memorandum

RE: COMMUNICATION - ITEM #38, COMMITTEE OF THE WHOLE, NOVEMBER 26, 2013

ZONING BY-LAW AMENDMENT FILE Z.12.042
SITE DEVELOPMENT FILE DA.13.033
EMPIRE PACE (MAPLE) LTD.
WARD 1 – VICINITY OF MAJOR MACKENZIE DRIVE AND KEELE STREET

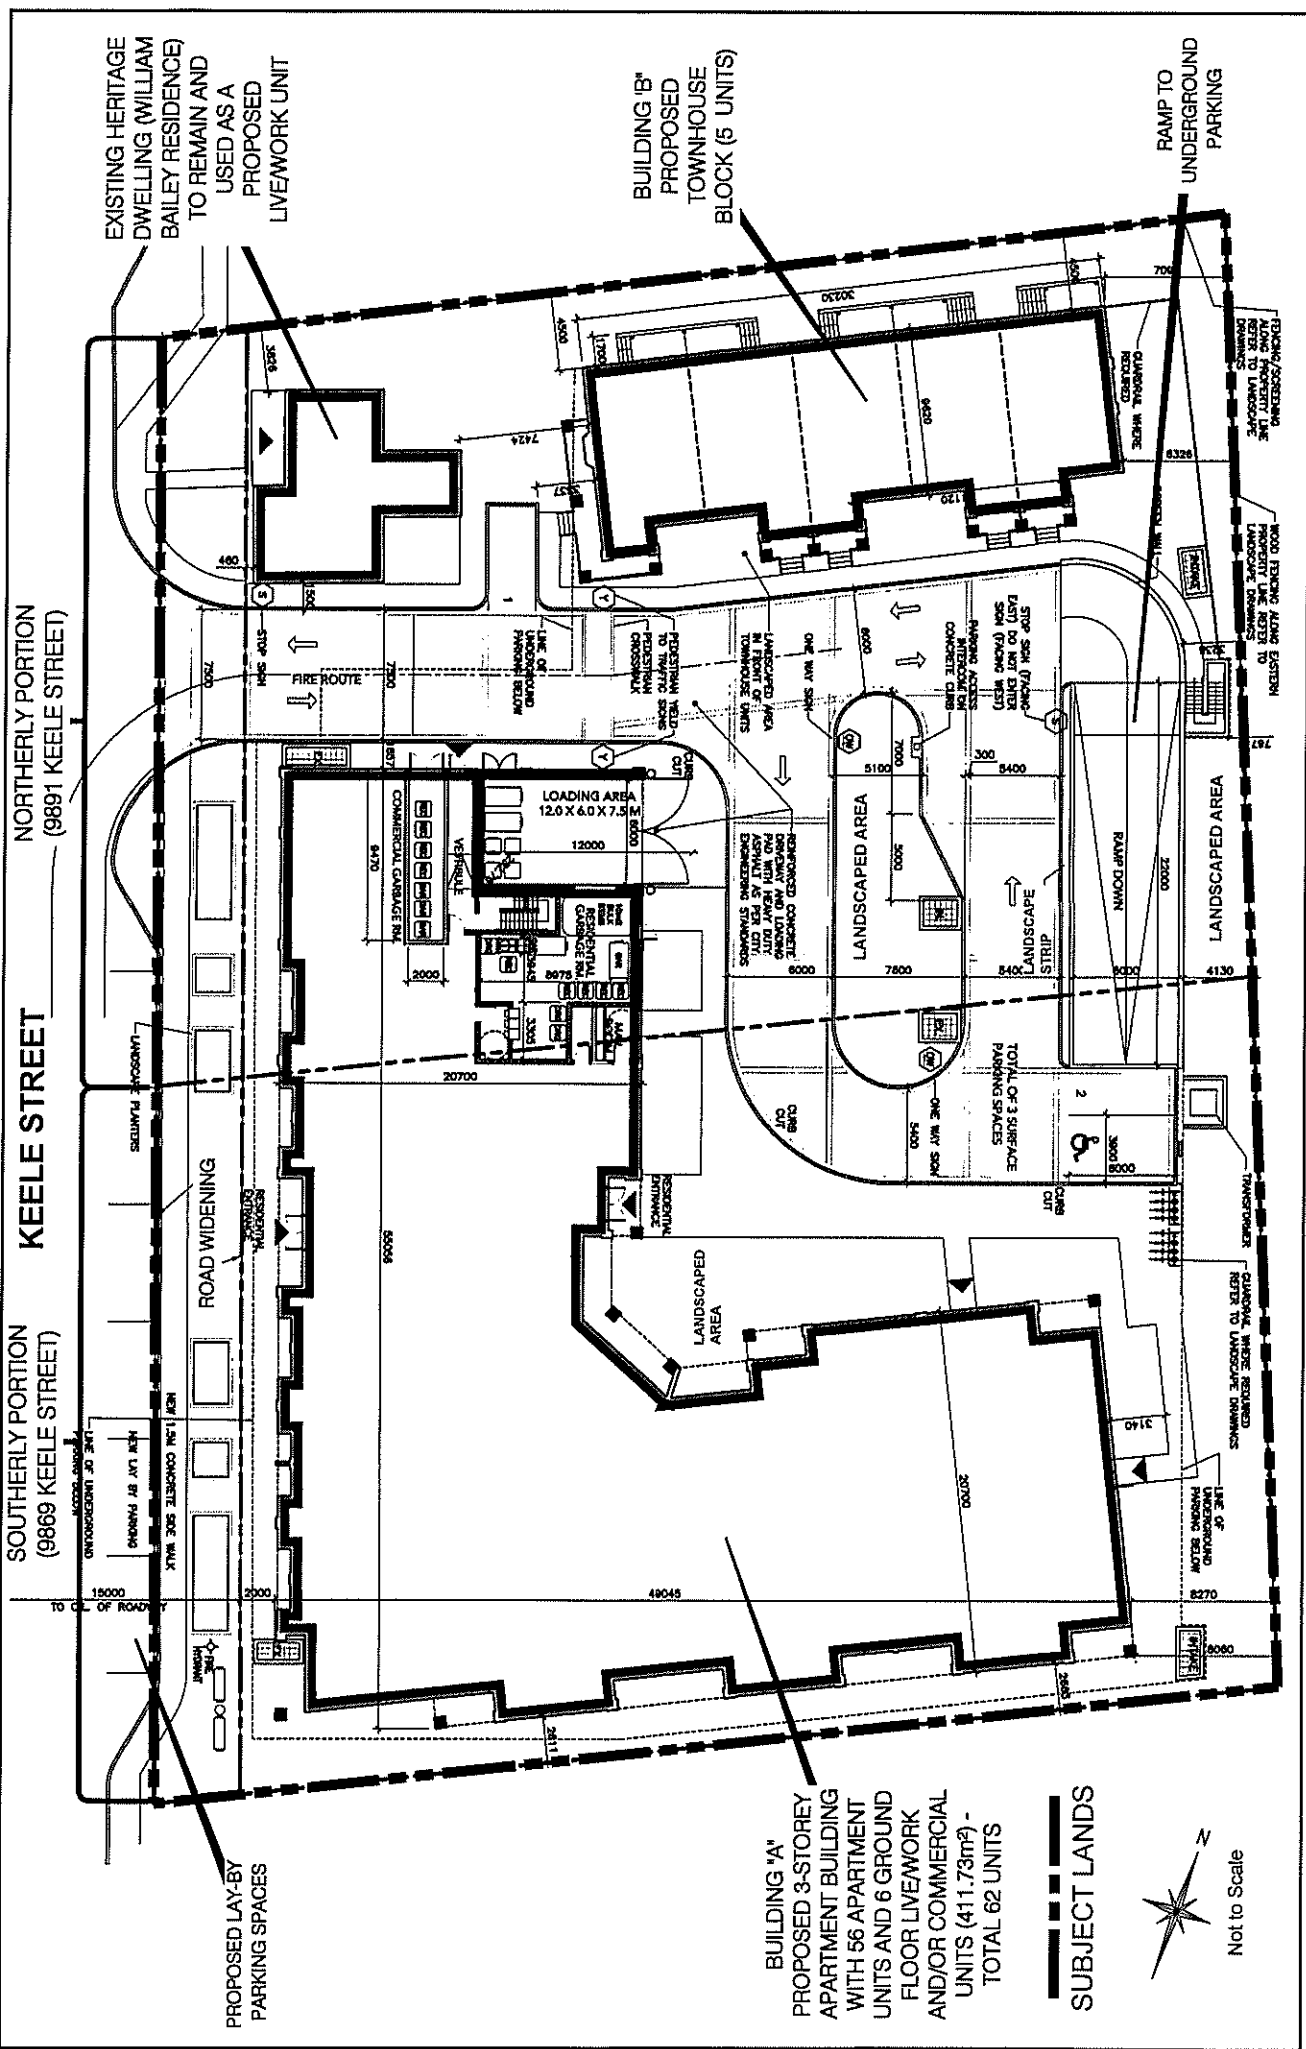
Attachments #3 (Site Plan) and #6 (Landscape Plan) make reference to 56 total units and must be replaced with the Attachments #3 and #6 in this Communication, to accurately reflect the number of units (62) proposed for Building "A".

2. THAT the revised site plan and landscape plan attached to this Communication, replace the original Attachments #3 and #6 of the November 26, 2013 report by the Commissioner of Planning and the Director of Development Planning, Item #38 of Report #52.
